SUBMITTAL SUMMARY REPORT

ImprovePin-000635-2026

PLAN NAME:	Atlas Tranquility Park	LOCATION:	8545 E HWY 25 BELLEVIEW,
APPLICATION DATE:	04/16/2026	PARCEL:	39279-026-00
DESCRIPTION:	Atlas Tranquility Park

OCE: Plan Review (DR) v.2

6.12.9 (H) - Subdivision roads and related infrastructure

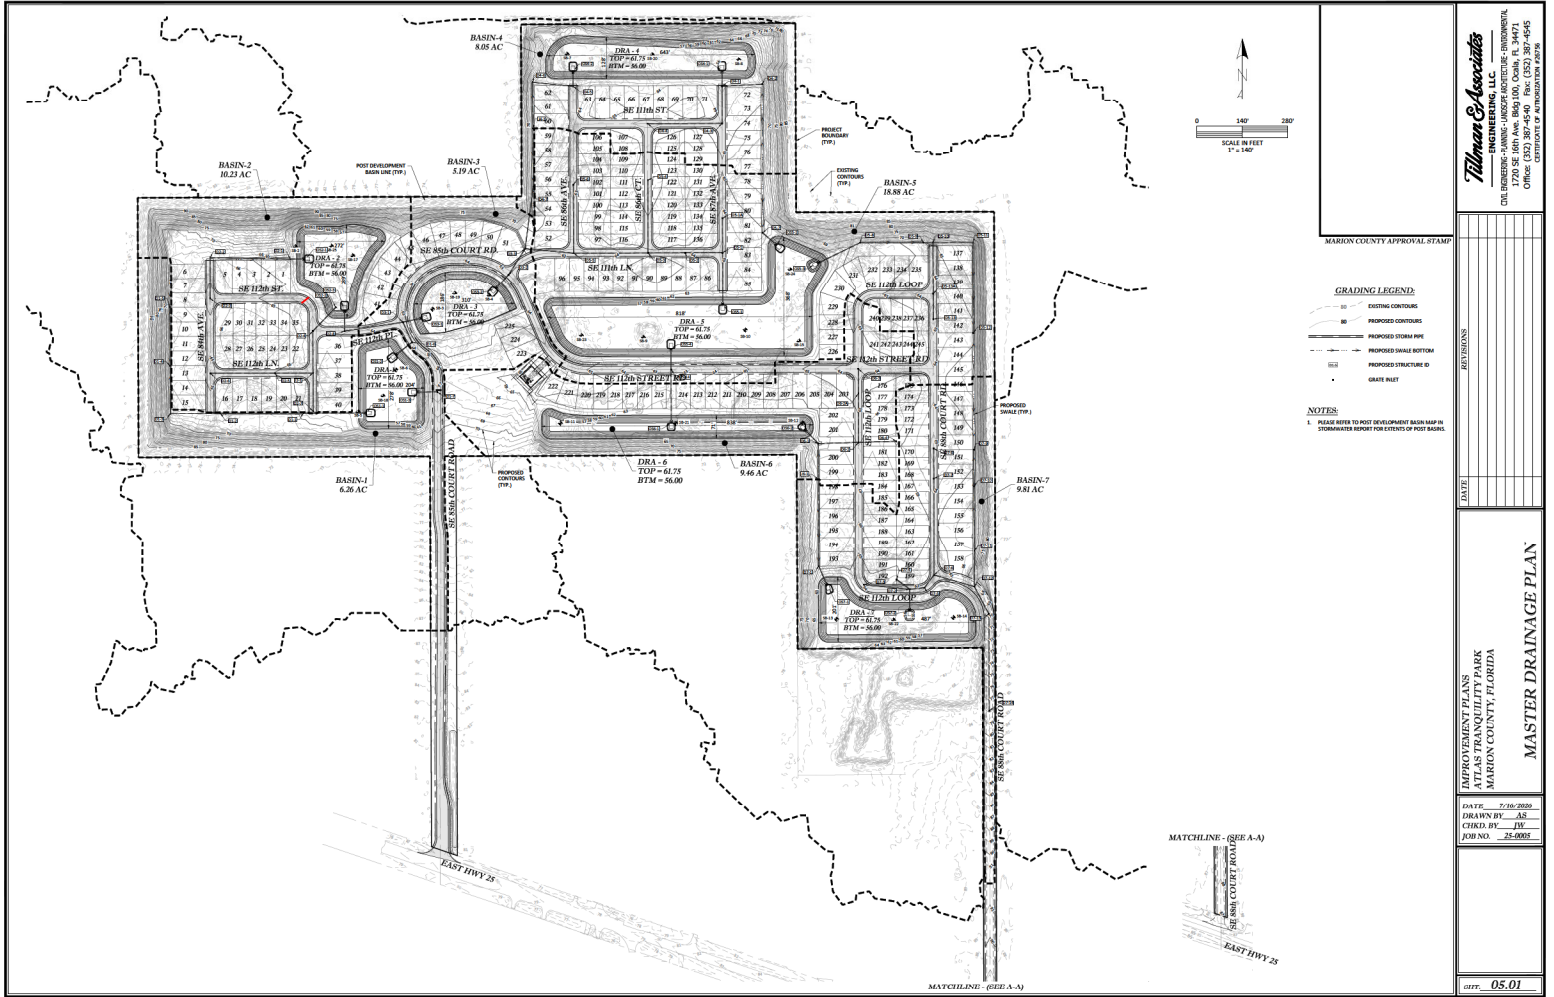
Requests a waiver to allow for dead end roadways without a cul-de-sac. The dead ends will be less than 150' in length.

OCE Traffic (Permits & Plans) (Office of the County Engineer)	Sydney Oberdorfer	07/28/2026	07/24/2026	Requires Re-submit
Corrections	6.12.9 - Subdivision roads (Not Resolved) - Corrective Action: A waiver was approved to provide hammerhead-style turnarounds on dead end segments less than 150' in length. Please show these turnarounds on dead-end segments in plans. - 6.12.9 - Subdivision roads : Subdivision roads must meet the design requirements in Section 6.12.9.			
Corrections	6.12.2 - Right-of-way (Resolved) - Corrective Action: Please address the comments on the Preliminary Plat. - 6.12.2 - Right-of-way: Show the right-of-way width.
